(Amendment Letter)
**MASTER DEVELOPMENT DRAINAGE
PLAN AND FINAL DRAINAGE REPORT**
for SHILOH MESA & SHILOH MESA
FILING NO. 1 and FINAL DRAINAGE
REPORT for SHILOH MESA
FILINGS NO. 2 AND NO. 3

Project #08-026

RE: Amendment Letter to the Master Development Drainage Plan and Final Drainage Report for Shiloh Mesa Filing No. 1 & Final Drainage Letter for Shiloh Mesa Filing No. 2 & 3.

EXHIBIT 1 DRAINAGE BASIN REVISION FOR MASTER DEVELOPMENT DRAINAGE PLAN AND FINAL DRAINAGE REPORT FOR SHILOH MESA FILING NO. 1 & FINAL DRAINAGE LETTER FOR SHILOH MESA FILING NO. 2 & 3

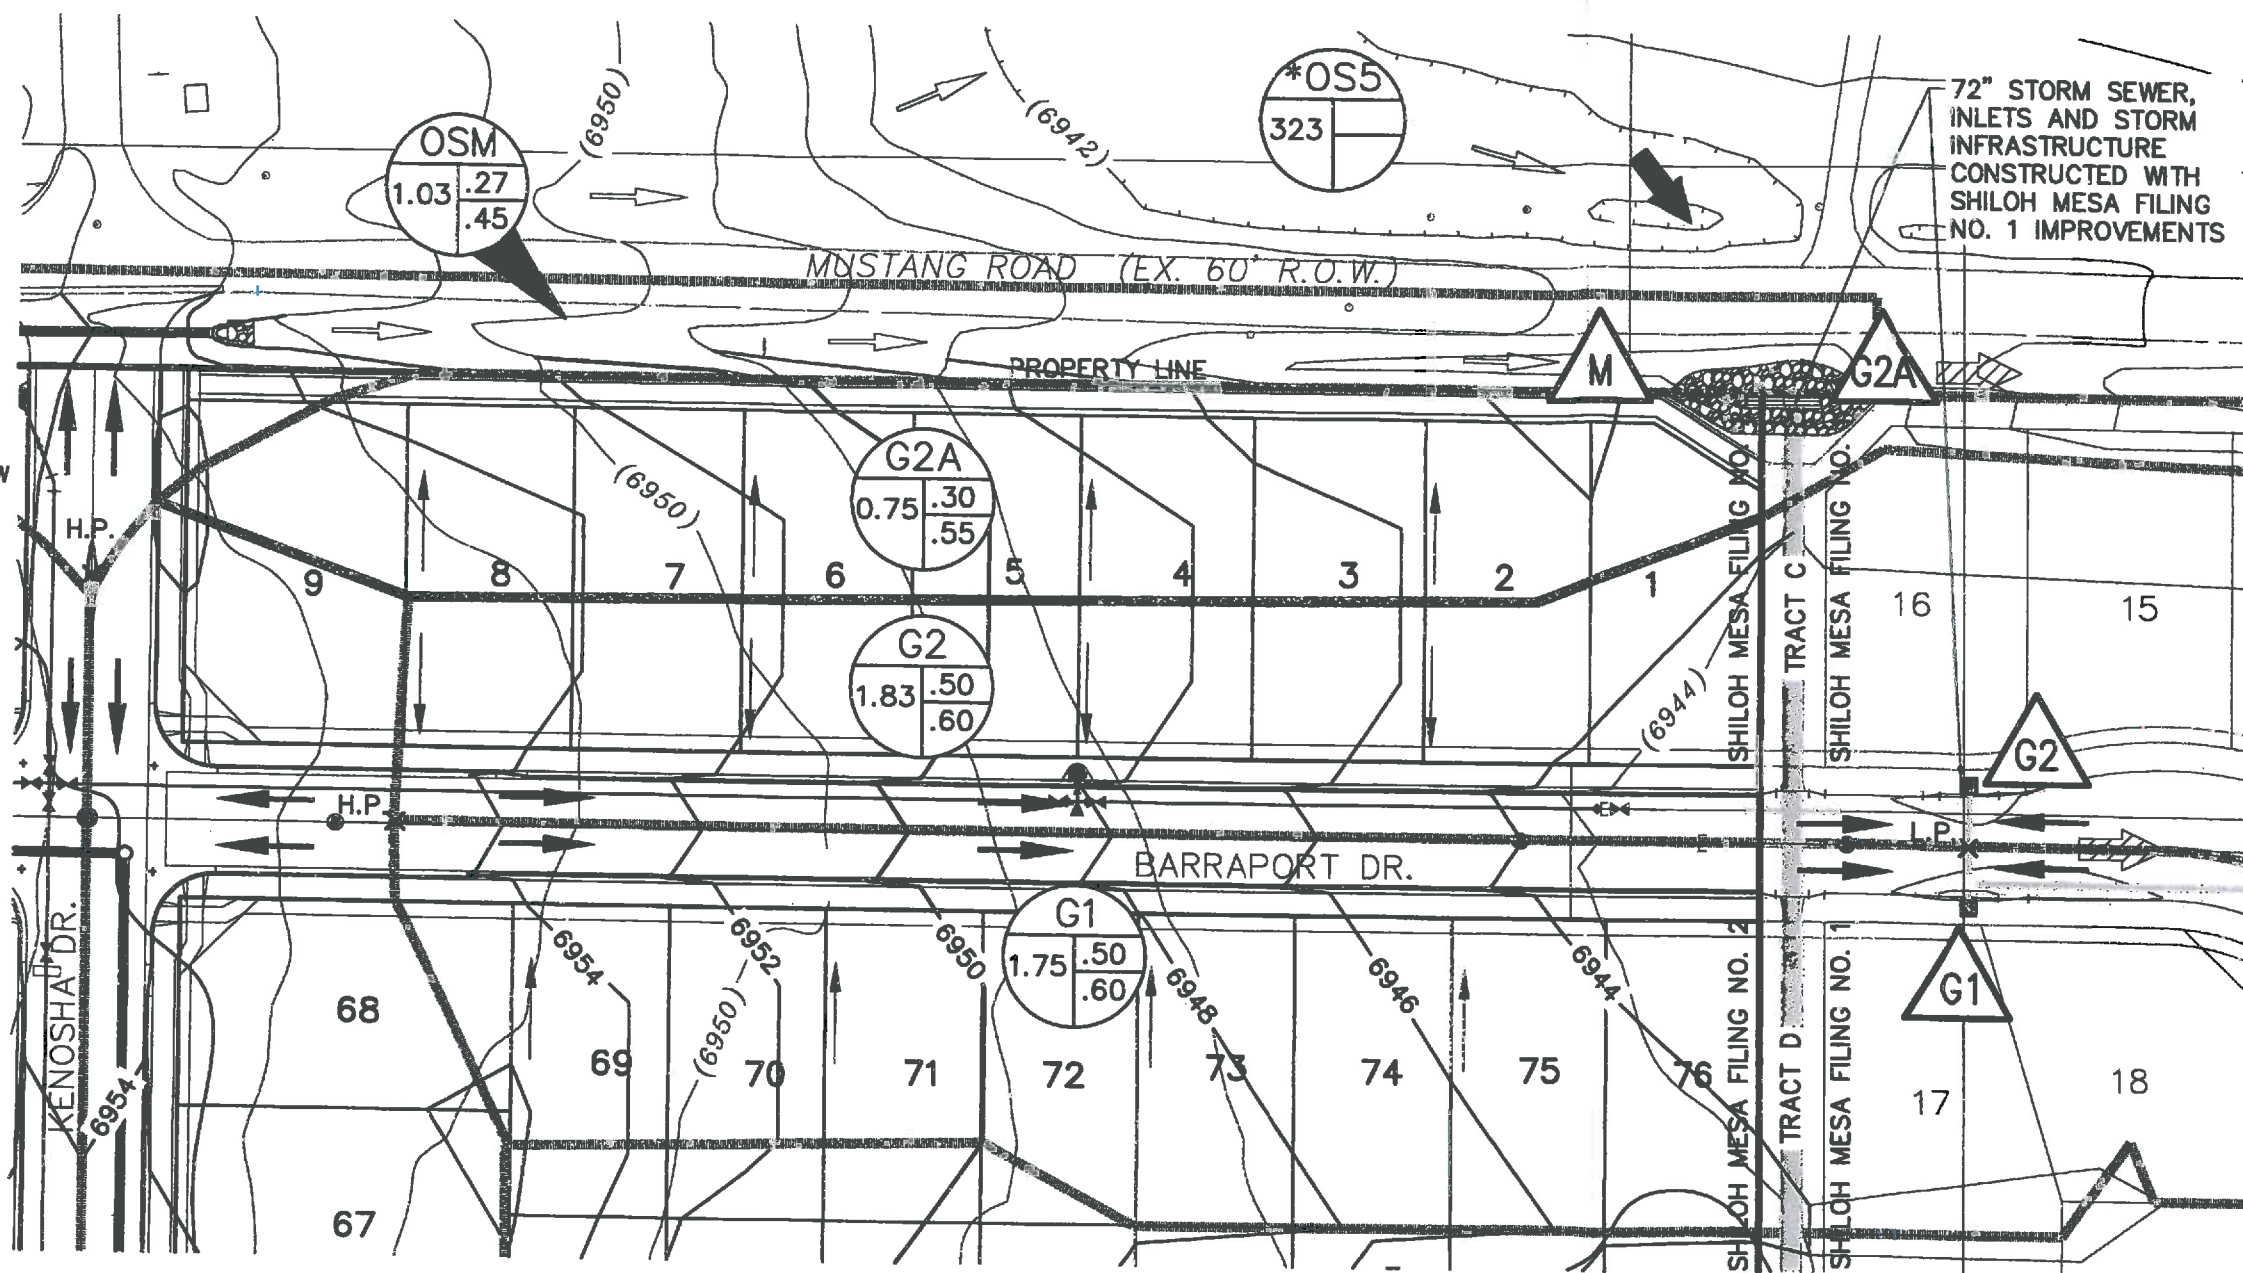
This letter is being prepared to accompany the proposed Final Plat for Shiloh Mesa Filing No. 2 (20.310 acres) & Filing No. 3 (14.554 acres). Grading changes will result in Drainage Basin G2 being divided into two basins (Basin G2 and Basin G2A, see Exhibit 1 Drainage Basin Revision). Basin G2A is located in the southeast corner of Filing No. 2, and contains 0.75 acres of backyards of single family residential lots. Runoff from roof drains shall drain to the front of the lot and will flow, via side lot swales, to the curb and gutter to Design Point G2. Basin G2A has proposed design flows of $Q_5=1.0$ cfs and $Q_{100}=2.9$ cfs (see Exhibit 2 Area Drainage Summary). Runoff from Basin G2A will sheet flow to the existing swale parallel to Mustang Road (Basin OSM). Basin OSM is located off-site and parallels the east edge of Shiloh Mesa Filing No. 2 & 3, and contains 1.03 acres of paved street and vegetated road swale. Basin OSM has design flows of $Q_5=1.2$ cfs and $Q_{100}=3.6$ cfs. The cumulative flows at Design Point M are $Q_5=2.2$ cfs, $Q_{100}=6.5$ cfs (see Exhibit 3 Basin Routing Summary) and are conveyed south to Design Point G2A. The roadside swale has the capacity to carry 21 cfs at a one foot depth (see Exhibit 4 Open Channel Calculation). The road side swale has an approximate depth of four and a half feet at Design Point G2A. The flows are combined with flows from Basin *OS5 ($Q_5=72$ cfs, $Q_{100}=340$ cfs). The cumulative flows at Design Point G2A are $Q_5=72.7$ cfs, $Q_{100}=341.4$ cfs. The modified CDOT inlet at Design Point G2A has been sized to accept flows in the developed condition (see Exhibit 5 Weir and Orifice Calculation and Exhibit 6 Pipe Flow Calculation). Basin G2 is located in the southeast area of Filing No. 2, and contains 1.83 acres of single family residential lots and streets. Basin G2 has proposed design flows of $Q_5=3.7$ cfs and $Q_{100}=8.0$ cfs (see Exhibit 2 Area Drainage Summary). Runoff from Basin G2 will flow via curb and gutter to the existing Design Point G2. The proposed flows to Design Point G2 are less than the flows from the "Master Development Drainage Plan and Final Drainage Report for Shiloh Mesa & Shiloh Mesa Filing No. 1", prepared by M&S Civil Consultants, Inc., Design Point G2 ($Q_5=5.3$ cfs, $Q_{100}=11.2$ cfs). There is no change to Basin G1, shown only as reference. The overall grading changes will not adversely affect downstream inlets and storm infrastructure.
